**Summary of EPA's Response and Findings
Related to the February 2014 Radioactive Release at the
Waste Isolation Pilot Plant**

Prepared by the Office of Air and Radiation
Office of Radiation and Indoor Air

September 2014

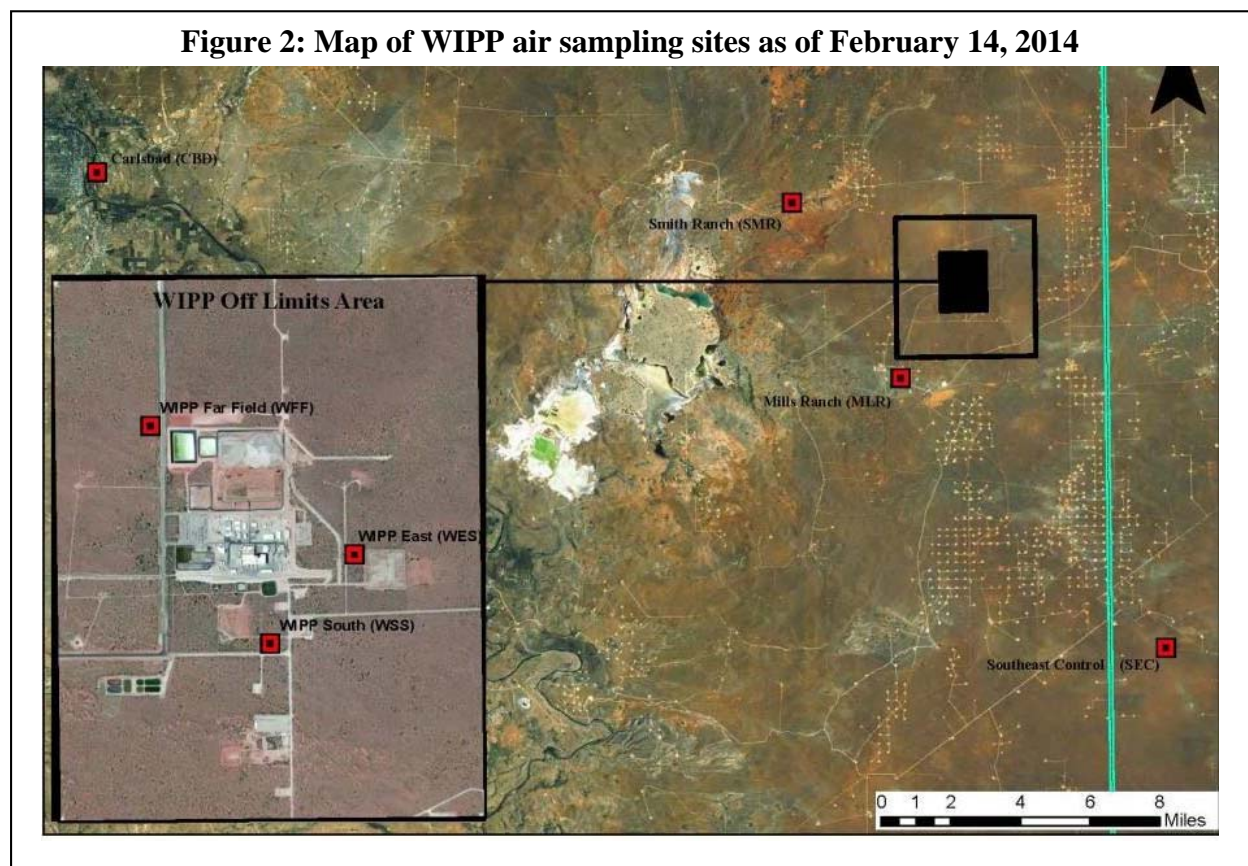
At the time of the incident, DOE's network comprised seven ambient air samplers in the vicinity of the WIPP. The location of these samplers accounted for the predominant wind direction in the area and the location of known residents and population centers in this sparsely populated area. The sampling locations included a "control" point in the expected upwind direction from the WIPP. Placement of this air sampler provides a baseline background level against which to compare possible releases and a limited ability to detect radioactivity if winds shift from the expected predominant direction. Figure 2 includes the locations of DOE's ambient air samplers operating during the February 2014 release.

During the February 2014 release, the winds at the WIPP were blowing predominantly in the northwesterly direction and DOE's ambient air monitoring network in place on February 14 did detect and measure the off-site levels of radioactivity. The levels detected were consistent with those projected by modeling and did not pose a hazard to public health or the environment.

additional samplers now in place, EPA believes that DOE's ambient air monitoring network—in terms of instrument capability as well as the number and location of stations—is not sufficient to reliably detect and quantify air releases that do not follow the predominant wind direction. In the event of such a release, particularly one significantly larger than the February 2014 release, it would be difficult for DOE to confirm its modeling results and provide the information necessary to address public concerns.

Update the Ambient Environmental Monitoring Network: DOE needs to improve the design, positioning, maintenance and overall capability of its ambient environmental air monitoring network.

In reviewing the ambient monitoring network, DOE needs to update the network to account for the additional uses and demands for ambient air monitoring during a release. DOE may make changes to the existing design of the repository—such as installation of a new air exhaust shaft¹⁶—in response to the incident. If these changes affect the magnitude, release point, or direction of potential releases in the future, DOE will need to ensure the network addresses such changes. DOE should use a data quality objective process to define the type, quality and quantity of data needed to reach accurate and defensible conclusions.
